CITY OF SAN ANTONIO

Re: Carlson Park

POADP # 672

PRELIMINARY OVERALL AREA DEVELOPMENT PLAN
 FILE NO. _____

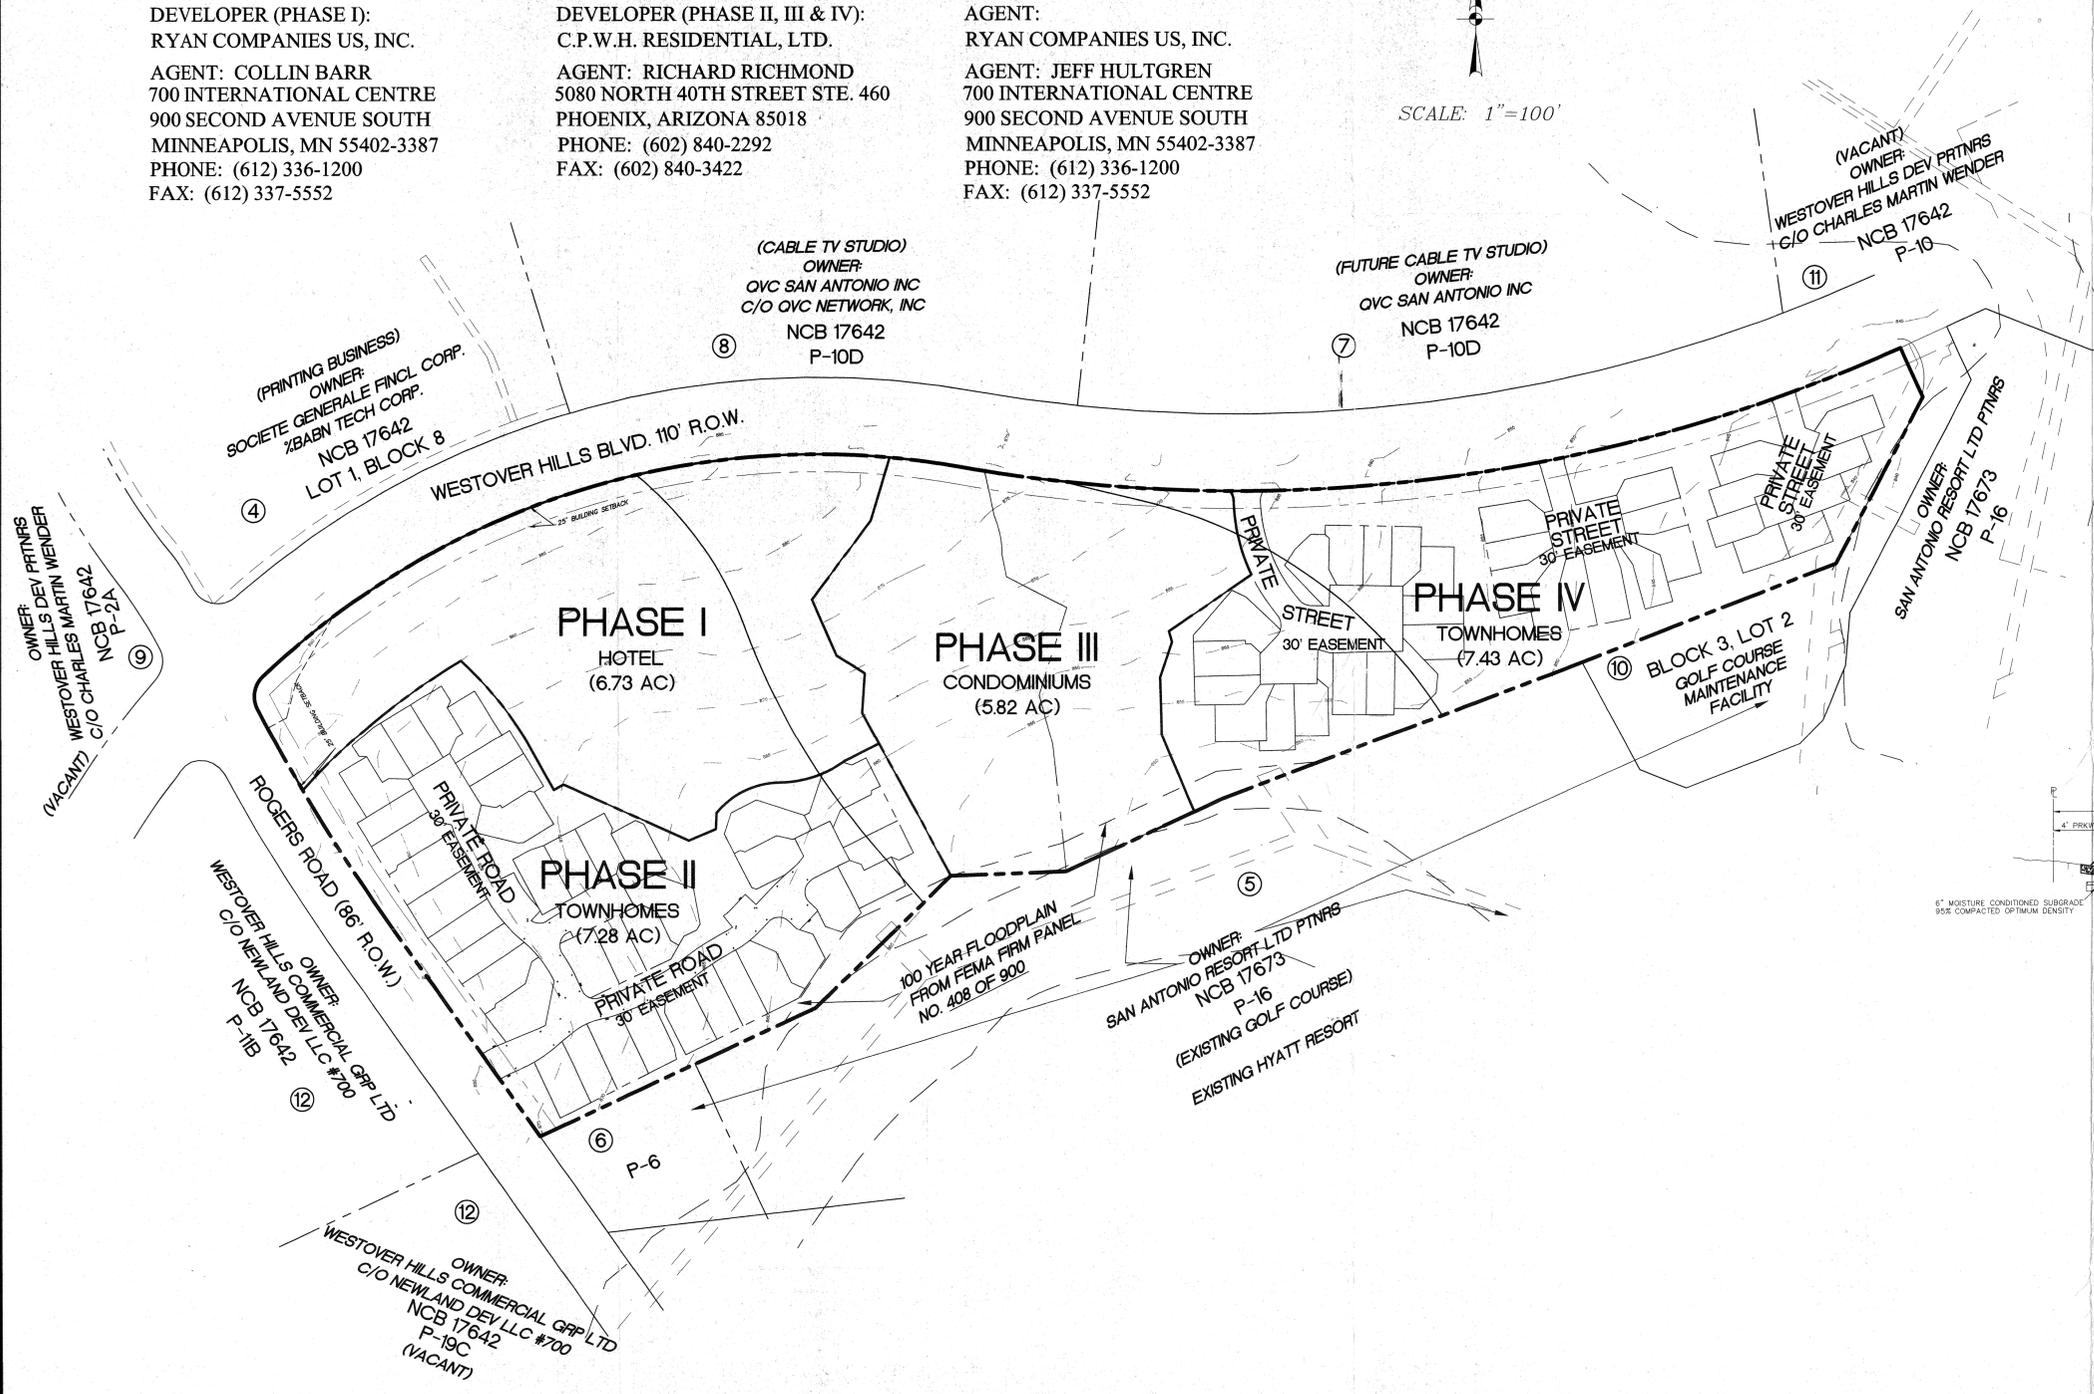
- Based on the topography, a Flood Plain Study and drainage review will probably be required during the platting process. Bexar County Public Works may require base flood elevations at the plat level.

- In consideration of public safety and convenience, excessive grades by reason of topography should be avoided in street layouts and arrangements.
- This development will probably need to conform to requirements associated with development over the Edwards Aquifer. For additional information about these requirements you can contact SAWS at 704-7305.

- Access and R.O.W. issues along State facilities will need to be resolved with the Texas Department of Transportation (TXDOT). For information about these requirements you can contact TXDOT at 615-5814.

- This development will need to comply with tree preservation ordinance #85262. For information about these requirements you can contact Building Inspections at 207-7102.

- It will be expected that you will plat all of the property depicted in your POADP, to include: floodpains, drainage areas and open space.
- I would encourage you to work closely with the school district, so that they can plan accordingly.
